**PLANNED UNIT DEVELOPMENT &  
SUBDIVISION STAFF REPORT****Date: June 5, 2003**

<b><u>DEVELOPMENT NAME</u></b>	Springdale Mall Subdivision
<b><u>SUBDIVISION NAME</u></b>	Springdale Mall Subdivision
<b><u>LOCATION</u></b>	3250 Airport Boulevard (Northeast corner of Airport Boulevard and East I-65 Service Road South, extending to the South terminus of Springdale Boulevard)
<b><u>PRESENT ZONING</u></b>	B-3, Community Business
<b><u>AREA OF PROPERTY</u></b>	69.2± Acres / 4 Lots
<b><u>CONTEMPLATED USE</u></b>	Multiple buildings on multiple building sites, and shared access and shared parking between multiple building sites.
<b><u>TIME SCHEDULE FOR DEVELOPMENT</u></b>	Immediate
<b><u>ENGINEERING COMMENTS</u></b>	Must comply with all stormwater and flood control ordinances. Any work performed in the right of way will require a right of way permit.
<b><u>TRAFFIC ENGINEERING COMMENTS</u></b>	Driveway number, size, location, and design to be approved by Traffic Engineering and conform to AASHTO standards. Recommend review of the parking lot layout to address traffic circulation. Currently, Springdale Boulevard has an ADT of 13,600. The roadway around the building could encourage cut through

## SITE PLAN

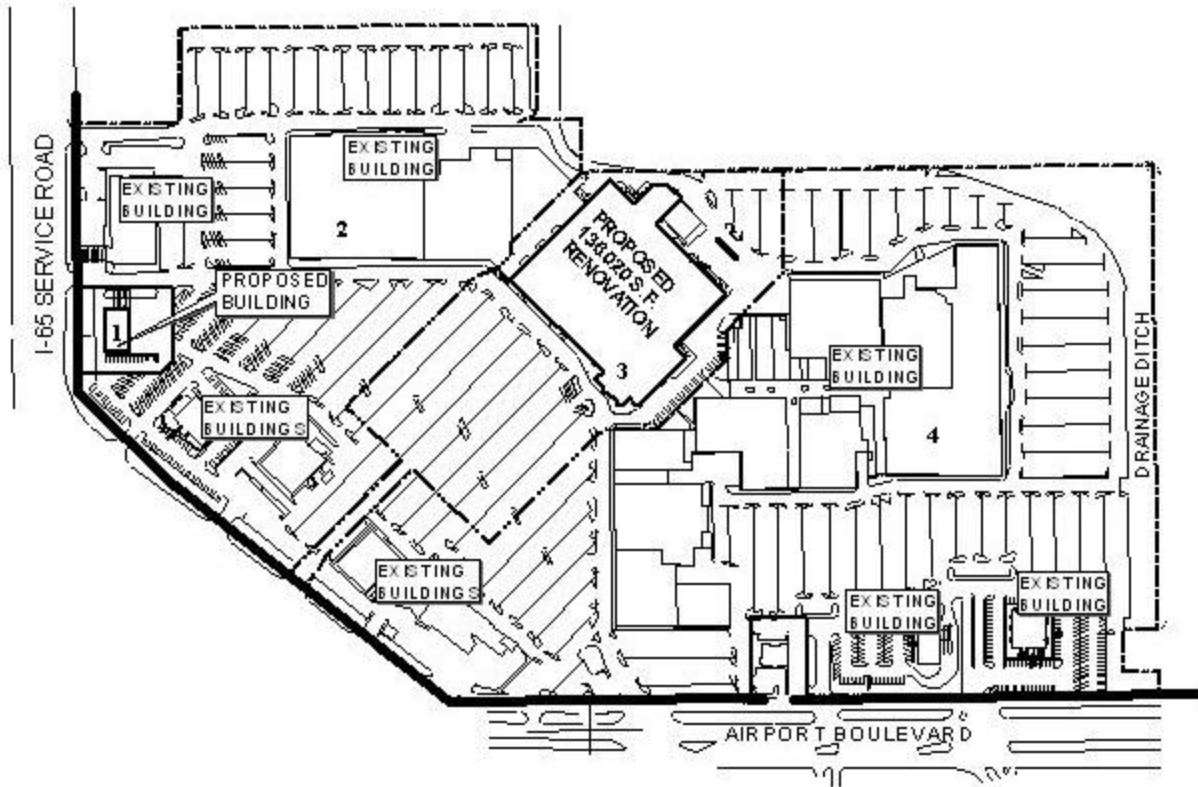
The site is located on the Northeast corner of Airport Boulevard and East I-65 Service Road South, extending to the South terminus of Springdale Boulevard. The plan illustrates the existing structures and parking along with the proposed building.
